## Staff Analysis

### **Expanded Overview:**

**Figure 1- Town of Swansboro Zoning Map**

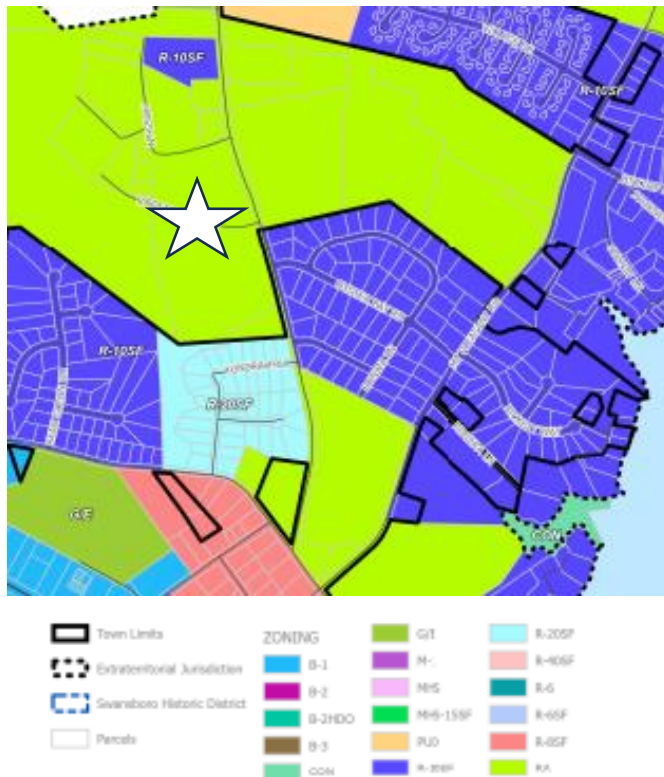
The requested conditional rezoning by Sand Dollar Homes contains a +/- 27.287-acre parcel of land currently zoned RA (Residential Agricultural to R-20SF see **(Figure 1)**). The rezoning request is consistent with the R-20 SF cluster development and is consistent with all Unified Development Ordinance requirements. The requested rezoning is consistent with the Swansgate subdivision zoned R-20 Cluster, the Oyster Bay subdivision across Swansboro Loop Road zoned R-10 and the other R-10 subdivisions in the area.

**Figure 2- Future Land Use Map**

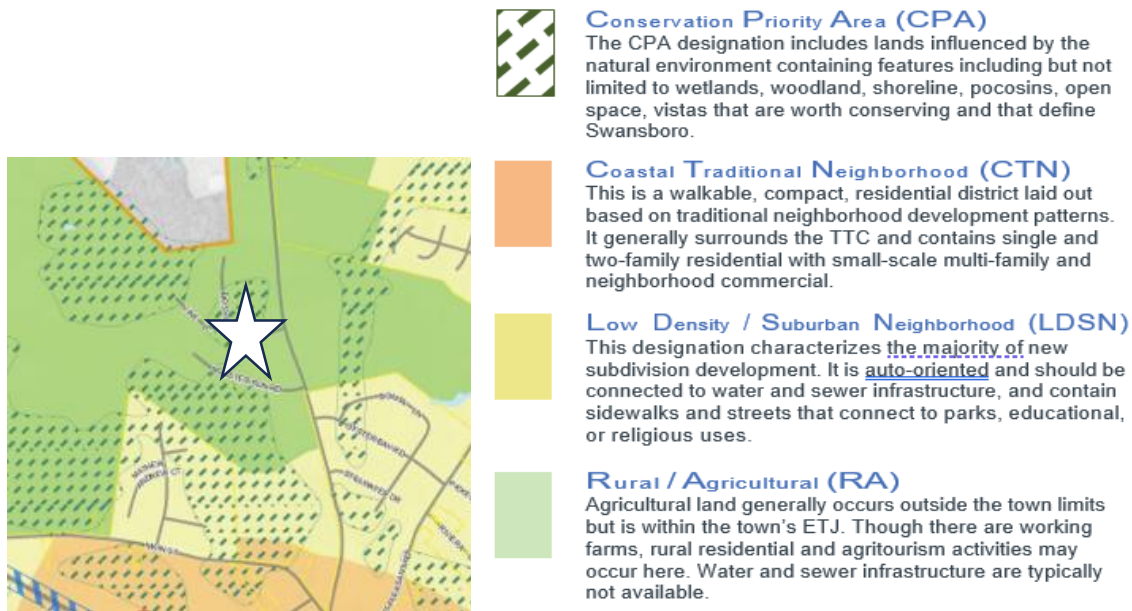
The CAMA Land Use Plan Future Land Use Map depicts this parcel as Rural/Agricultural and CPA (Conservation Priority Area). The Conservation Priority Area is because of the wetlands located on the site. Please see **(Figure 2)**. On August 28, 2023, an amendment to the CAMA Land Use Plan Update changed the analysis on pages A-29 and A-30 from protection of only isolated wetlands to protection of all environmentally sensitive areas. Further, the amendment included isolated wetlands in the definition of environmentally sensitive areas and protects wetlands when development is proposed with zoning incentives such as cluster development. Find the link below:
